**EVALUATION OF POTENTIAL SAFETY-RELATED PUMP LOSS  
FOR SAN ONOFRE UNIT 1 IN RESPONSE TO NRC BULLETIN 88-04**

**RESPONSE TO NRC COMMENTS REGARDING  
SONGS UNIT 1 RESPONSE TO NRC BULLETIN 88-04**

FIGURE 1

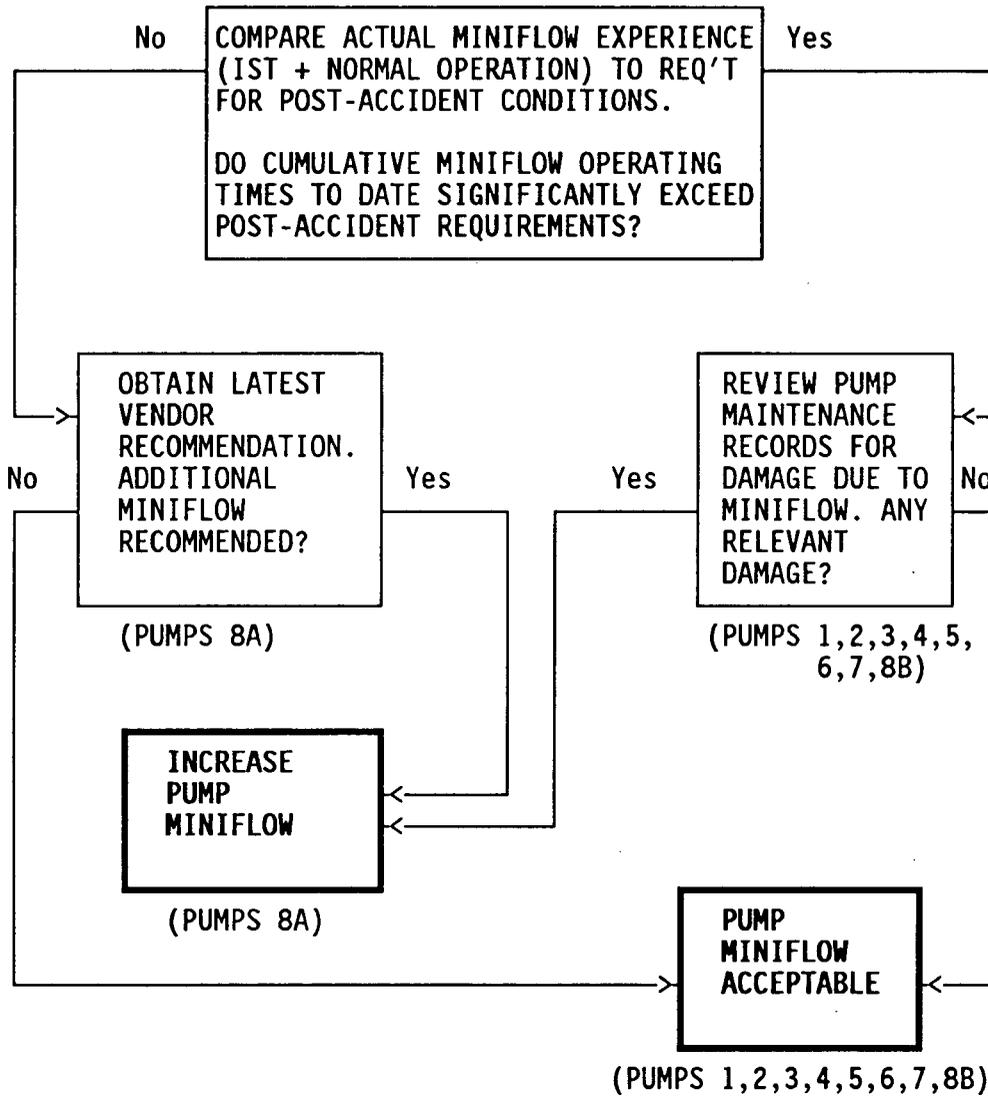
"Based on its review of IST data, the licensee concluded that miniflow rates are acceptable for all safety-related pumps except the feedwater pumps. Typically, a pump is operated over a period of 15 to 30 minutes for collecting IST data. This is not judged to provide a meaningful indication of how the pump would perform when operated in miniflow for considerably longer periods of time."

If there is no history of these types of problems and if the IST records do not indicate degrading trends, it can be reasonably concluded that operation at the existing miniflow is not producing measurable damage. The maintenance records from approximately 1984 to the present were reviewed. Over approximately the same time period, the pumps were operated in the miniflow mode for time durations exceeding the requirement for post-accident operation. The IST and the maintenance history data provide assurance that the pumps have not experienced damage attributable to low flow rates. Therefore it can be concluded that the pumps are adequate to provide miniflow service during post-accident operation. Figure 1 is a flow chart showing the procedure used for pump miniflow evaluation.
